SUBJECT: Responds to 850212 request for addl info re IE Bulletin
 80-11, "Masonry Wall Design." Encl data & evaluation
 demonstrate that stress-strain test data representative of
 DUR-O-WAL samples.

Subject: Duane Arnold Energy Center
Docket No: 50-331
Op. License No: DPR-49
IE Bulletin 80-11 Response -
Masonry Wall Design
Request for Additional Information
File: A-101a

RESPONSE TO THE REQUEST FOR ADDITIONAL INFORMATION
MADE BY THE NRC FOR
IE BULLETIN 80-11: MASONRY WALL DESIGN
DUANE ARNOLD ENERGY CENTER

Figure 1 Typical Block Wall Support Details

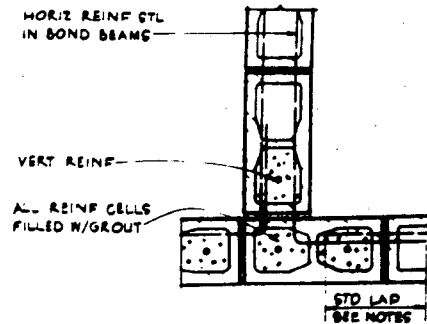
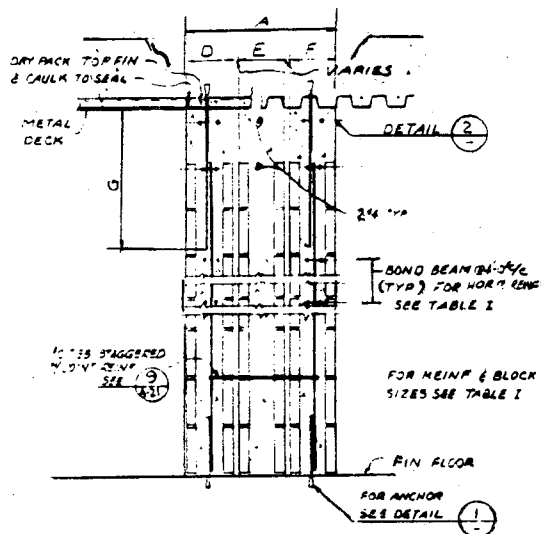
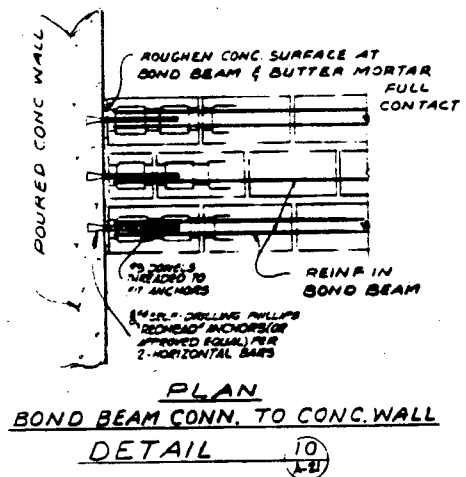
1. For those walls in which the calculated stress exceeded 40 ksi, please provide the following information for each wall: calculated stress, wall's dimensions and thickness, type and spacing of reinforcement, and connection details at the boundary. Also, provide sample calculations (with necessary explanation to make them understandable) illustrating the analytical procedures used in obtaining the stress values.

The calculated stresses in the horizontal reinforcement, the wall dimensions and thickness, the type and spacing of the vertical and horizontal reinforcement, and the boundary conditions assumed in the analysis for the walls with a calculated stress exceeding 40.0 ksi are listed in Table 1. Typical support details are shown in Figures 1 and 2.

Figure 3 Typical Stress - Strain Curves for Plain Wire,
(Reference 1)

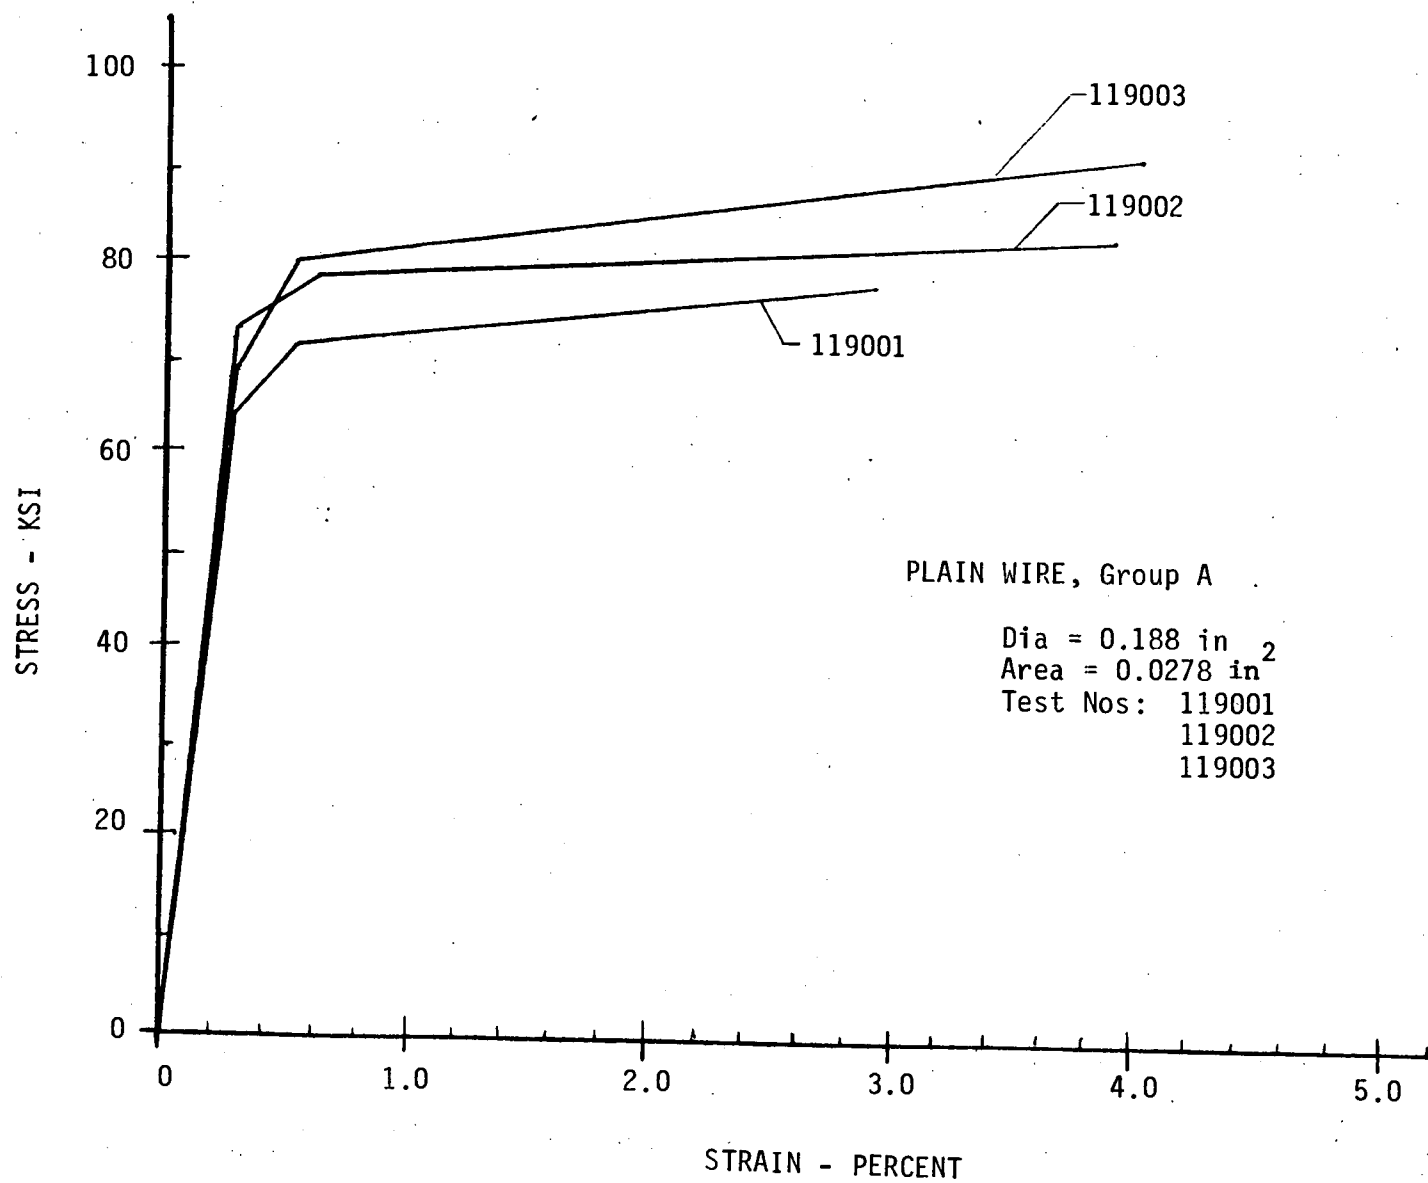
2. Provide the stress-strain relationship of the type of joint reinforcement used in the plant. If test data from the manufacturer are not available, it is recommended that some simple tests be conducted to obtain this relationship.

Figures 3 and 4 show stress-strain relationships (from References 1 and 2) for cold-drawn wire typical of that used in the manufacture of masonry joint reinforcing (DUR-O-WAL). The tests reported in References 1 and 2 were performed on wire utilized in the manufacture of welded wire fabric (WWF).

Joint reinforcing (such as DUR-O-WAL) is typically manufactured using ASTM A 82 cold-drawn plain or deformed wire. The joint reinforcing of DAEC consists of 3/16-inch (0.1875 inch) diameter longitudinal deformed wire with 9 gage (0.148 inch diameter) plain web, both conforming to ASTM A 82. Therefore, the stress-strain curves for plain and deformed wire (ASTM A 82 and ASTM A 496) shown in Figures 3 and 4 should be representative of DUR-O-WAL wire. These curves are based on stress-strain data selected from References 1 and 2 for wire sizes approximating the diameter of the longitudinal DUR-O-WAL wire (3/16 or 0.1875 inch). A comparison of the minimum required physical properties for ASTM A 82 and ASTM A 496 wire in this size range is shown in Table 2. As indicated in Table 2, the requirements are similar except for the bend tests, which are less restrictive for the deformed wire (ASTM A 496). A comparison of Figures 3 and 4, however, shows very little difference in stress-strain characteristics for deformed and plain wire. Both sets of curves reflect ductile behavior.
